**Drive Block CT7 Piston Replacement**

**Instruction No.:** HR28\_CI01

**Product:** HR28

**Operation:** Replace the CT7 piston valve within drive block P28571

3. Replace the 3-piece piston valve.

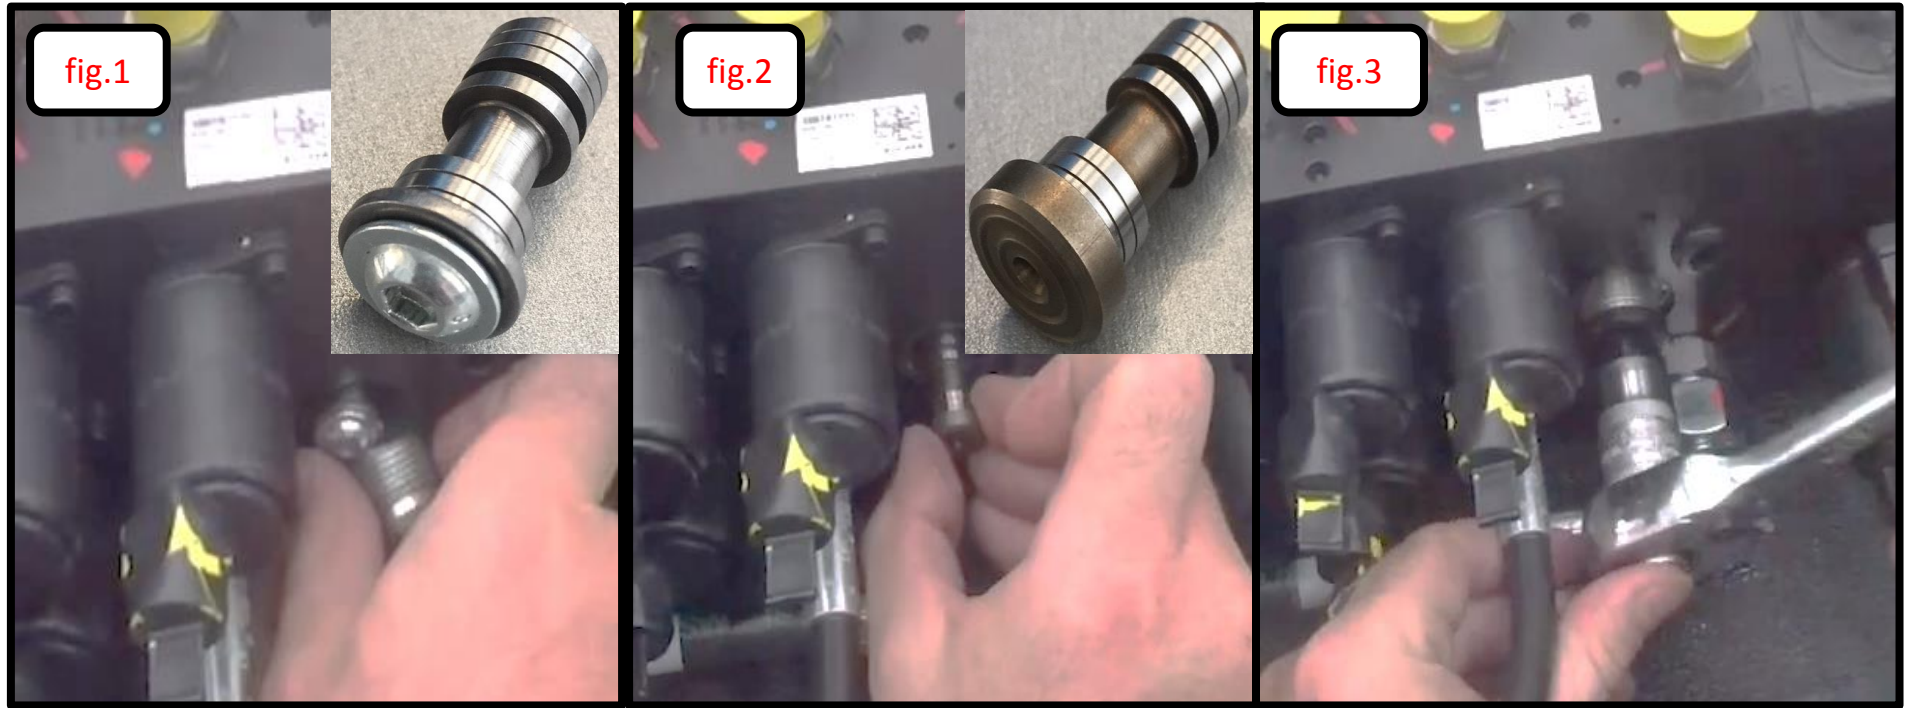
Remove the 3-piece piston valve from port CT7 (fig.1) ensuring the spring behind it remains in place and replace it with the single piece piston valve (P32504) (fig.2). Lock the piston back in place with the CT7 plug (fig.3).
